Midway Road Landscape Coordination with the Master Transportation Plan

November 13, 2018

MIDWAY ROAD REVITALIZATION
 Spring Valley Rd to Keller Springs Rd
 Town of Addison, TX Job #18-01
 Town of Addison Project # ADD201815
 August 2018

Required Visibility Triangles

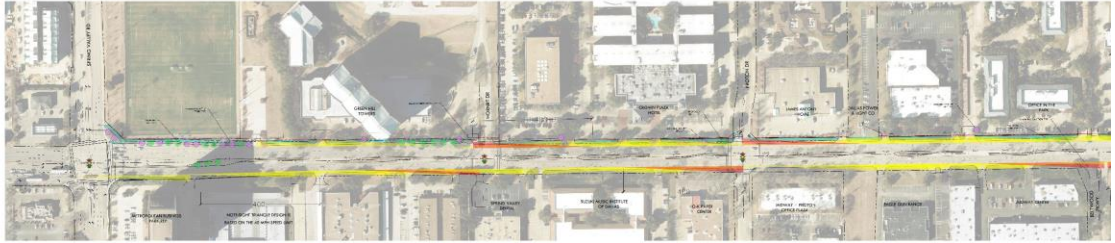
- As the consultant is incorporating the MTP into the roadway design several concerns have arisen:
 - Per the Town's Transportation Technical Design Standards, the engineering visibility triangles must be applied to both streets intersections and driveway approaches. Those standards state that "adequate sight distance at the intersections of roadways with other roadways and with driveways must be ensured. On Midway Road, the required engineering visibility triangle is 15'X400' from the intersection of a roadway or driveway."

- Applying the required visibility triangle will not allow trees to be planted within the 6' landscape buffer allotted in the MTP.

Master Transportation Plan Cross Section

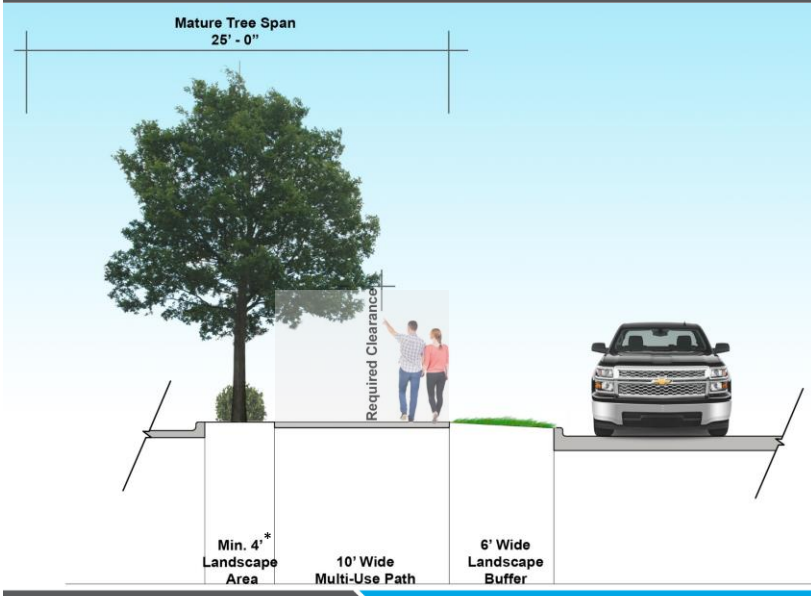
- **Current Design** - Corridor is 16' Wide with 1' transition to existing conditions.
- Trees would fall within the required 15' x 400' visibility triangle, and are not allowed per the Town's Technical Design Standards.
- Trees planted 4' from the roadway would have conflicts with larger vehicles.
- Required 14' clearance over the roadway would impact the shape of the trees.
- More of the road would be shaded than sidewalk.

Proposed Revision – Preferred Scenario

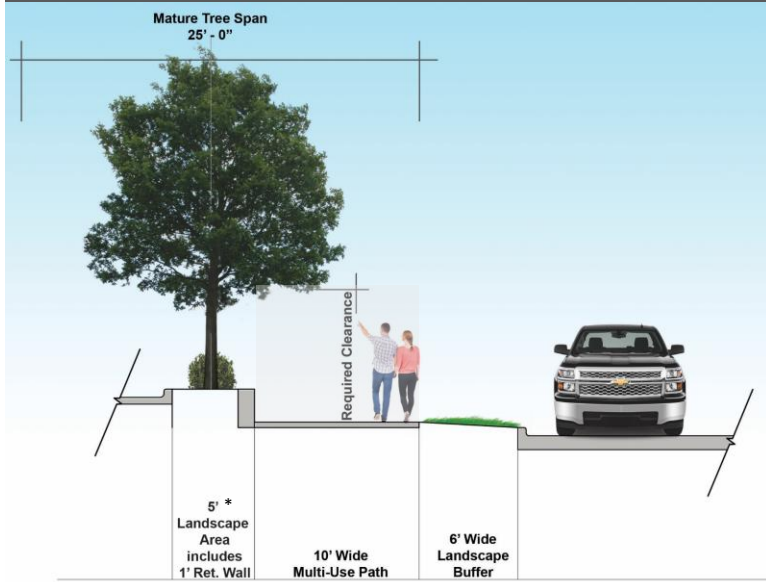
- **Proposed Corridor** – Width increased to 20' wide.
- Place trees and screening shrubs between private property and the trail, away from the roadway.
- Where space allows, or where parking is drastically impacted, create a 6' buffer between the trail and back of curb.
- Required clearance over trail is less stringent than over the roadway and less impactful to the tree.
- This proposal would better shade the sidewalk.

Proposed Revision – Preferred Scenario

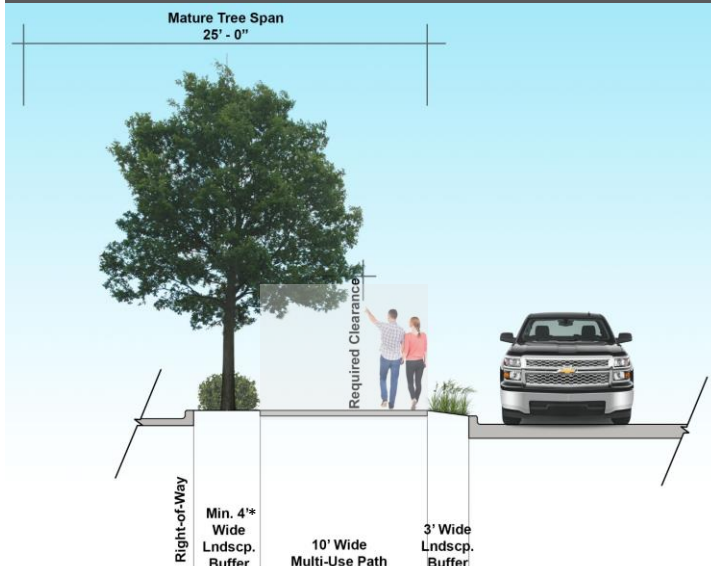
▪ **Proposed Corridor With Retaining Wall** – Width increased to 21' wide.

- Place trees and screening shrubs between private property and the trail, away from the roadway.
- Where space allows, or where parking is drastically impacted, create a 6' buffer between the trail and back of curb.
- Required clearance over trail is less stringent than over the roadway and less impactful to the tree.
- This proposal would better shade the sidewalk.
